ADMINISTRATIVE AMENDMENT (PD) ADD2007-00152

ADMINISTRATIVE AMENDMENT
LEE COUNTY, FLORIDA

WHEREAS, Morris Depew Associates Inc., filed an application for an administrative approval to a Commercial Planned Development (CPD) on a project known as Beachway Resort to **revise Pod #2 of the Master Concept Plan to:**

BEACHWAY RESORT
Section 07, T-46, R-24, Fort Myers Beach

ZONING MASTER CONCEPT PLAN

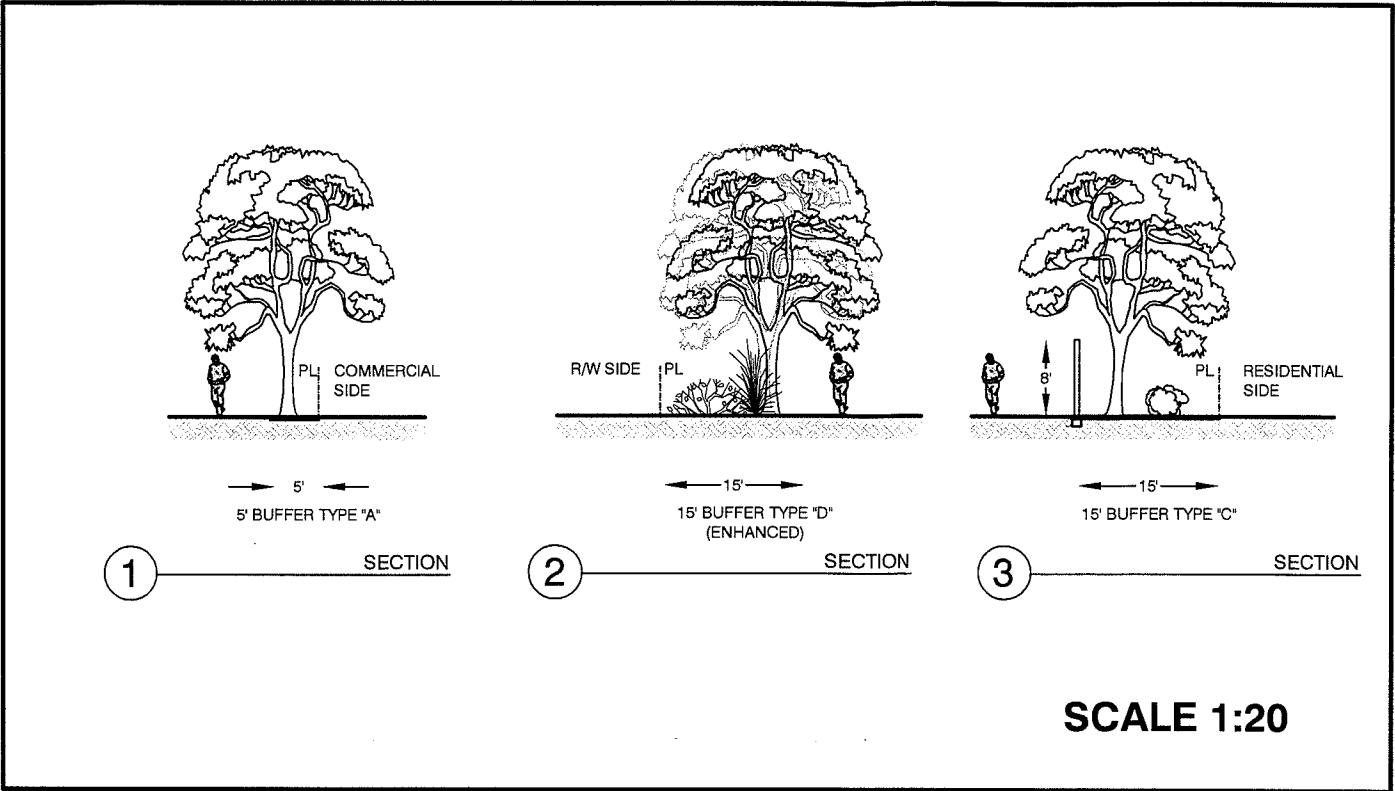
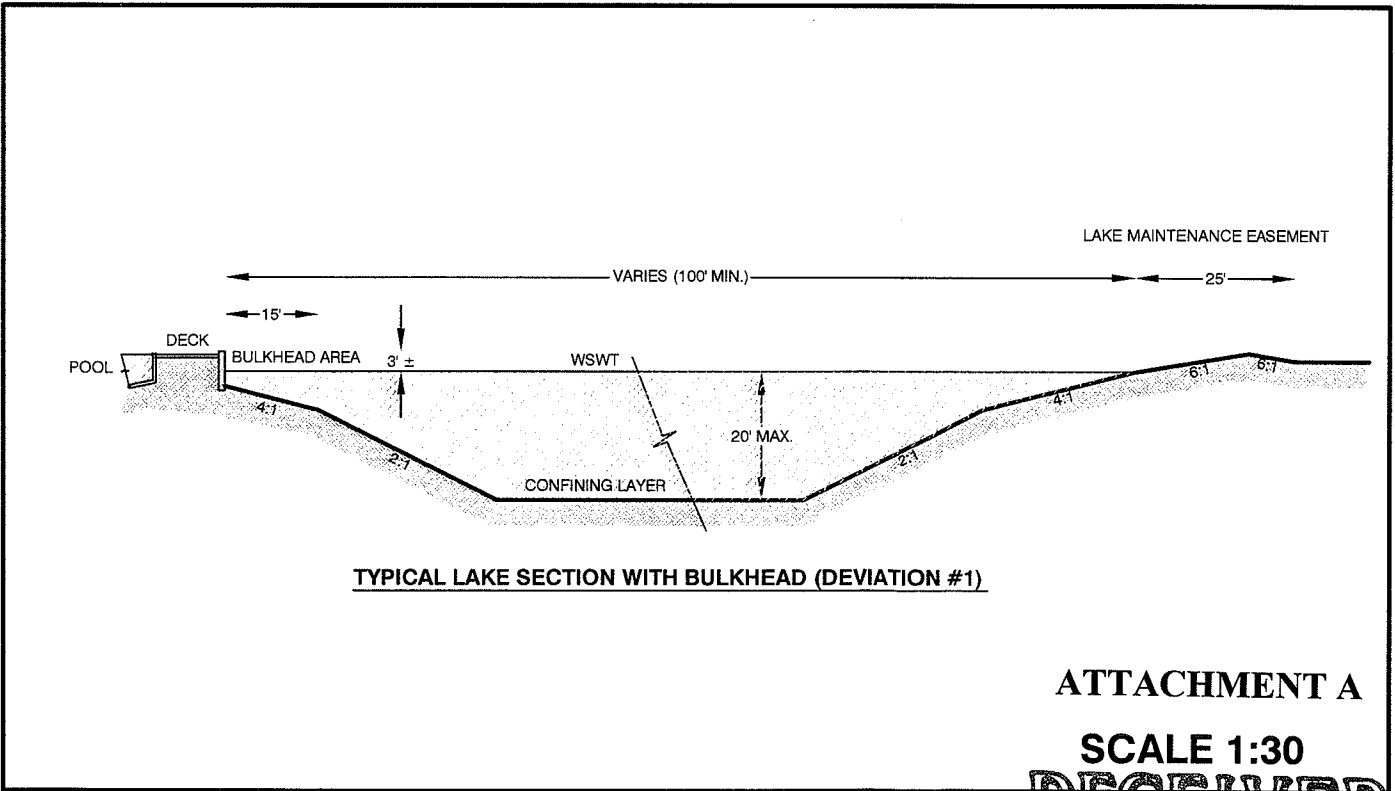
1. The only changes approved as part of this administrative amendment are:
 - Eliminate two of the 5 hotel buildings in POD #2 by combining two hotel/motel buildings with the administrative office/amenity building, resulting in the development of four buildings in Pod #2, containing a maximum of 290 hotel/motel units, and maintaining the maximum building height of 95 feet.
 - Enhance the buffer along Pine Ridge Road from a Type "D" buffer to an enhanced Type "D" buffer consistent with Condition 3 below.

2. The Development must be in compliance with the amended 2-page Master Concept Plan, stamped received August 10, 2007. Master Concept Plan for ADD2007-00152 is hereby APPROVED and adopted. A reduced copy is attached hereto as Attachment A.
3. The enhanced Type "D" buffer along Pine Ridge Road must be no less than 15 feet in width with 10 foot planting area and must consist of a minimum of:

1 PINE RIDGE ROAD ENHANCED BUFFER - TREE PLAN VIEW -
SCALE 1"=20'

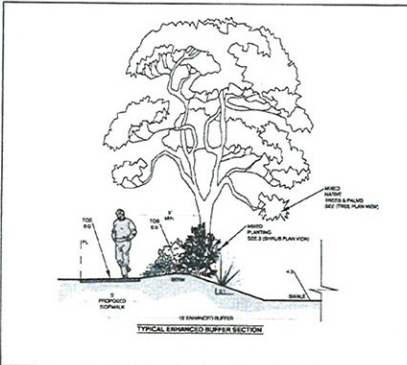
6.7 trees per 100 linear feet (total of 52)
97.4 shrubs per 100 linear feet (total 775), and
82.3 groundcovers , grasses, and littorals per 100 linear feet (total 638)

All plantings within this buffer must be 100% native species. Actual species and location of plantings will be worked out during local development order, as the changes within this amendment will require an amendment of the current local development order issued for this project.

The proposed plantings in this buffer must be sized in substantial compliance with the Materials Schedule as provided for on the draft Zoning Master Concept Plan - Enhanced Buffer drawing found as Attachment B to this action.
